APPEAL SUMMARY

Appeal ID: 18972	Project Address: 1120 SW 5th Ave
Hearing Date: 2/6/19	Appellant Name: Kristin Wells
Case No.: B-024	Appellant Phone: 503-823-1181
Appeal Type: Building	Plans Examiner/Inspector: Jeff Donnelly
Project Type: commercial	Stories: 15 Occupancy: B, A-2/3 Construction Type: I-A
Building/Business Name: The Portland Building	Fire Sprinklers: Yes - Provided throughout
Appeal Involves: Alteration of an existing structure	LUR or Permit Application No.:
Plan Submitted Option: pdf [File 1]	Proposed use: Municipal Office Building

APPEAL INFORMATION SHEET

Portland Building 2020 Restrooms

31
A12.1A LEVEL 01 RESTROOM - 0115 NORTH
SCALE: NOT TO SCALE

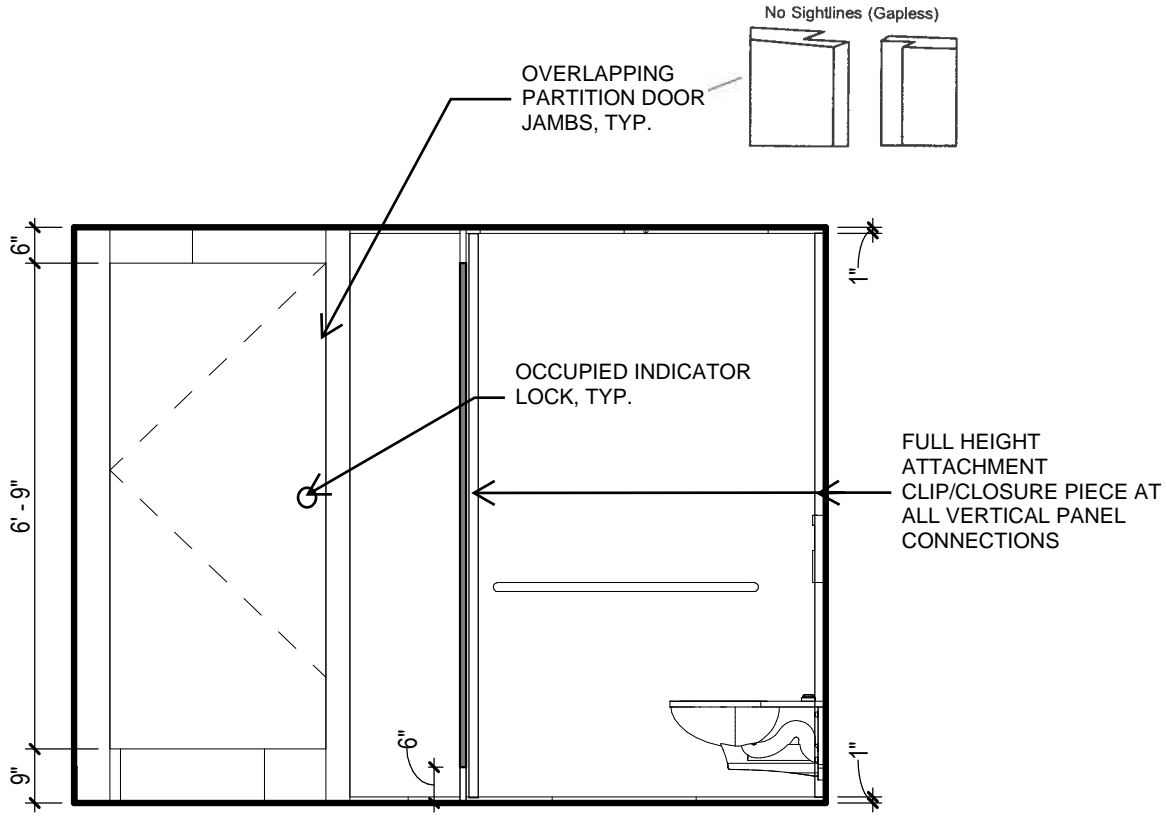
Each water closet is separated by toilet partition panels that sit 1" maximum above existing floor and 1" maximum below ceiling. The toilet partitions have continuous attachment clips at all vertical joints between walls and other partitions as well as continuous hinges and overlapping jambs to eliminate gaps. The typical stall doors sit 6" above existing floor and 6" below existing ceiling. At ADA stall, the door sits 9" above the floor to accommodate wheelchair foot rest clearance.

Overlapping jambs, occupied indicators, separate ventilation and lavatories are provided for in the design as noted in the attached drawings.

The proposed design meets all of the requirements as stated in the Code Guide with the exception of Item A that requires "Each water closet must be enclosed by a 6'8" minimum door that fills the door frame, and floor to ceiling partitions or walls;"

The applicant believes that the intent of the Code Guide is being met for separate facilities by using a partition system that eliminates gaps that would allow visibility into the stall. The Portland Building is an existing building with variations in floor surfaces that need to be accommodated. Holding the partitions 1" maximum from adjacent floor and ceilings allow tolerance for existing floor slabs that are out of level.

The space provided at the bottom of the stall doors is provided to address potential safety and security concerns. As this is a public building, the City is concerned with the ability to be aware of any restroom occupants that may be in need of security or medical assistance. The top of door is typically 7'-6" above the floor putting the top of the door well above the 6'-8" minimum required height.

Omission of separate toilet facilities with all user stalls: Granted provided the maximum gap at the top and bottom of the partition walls and doors is 1 inch.
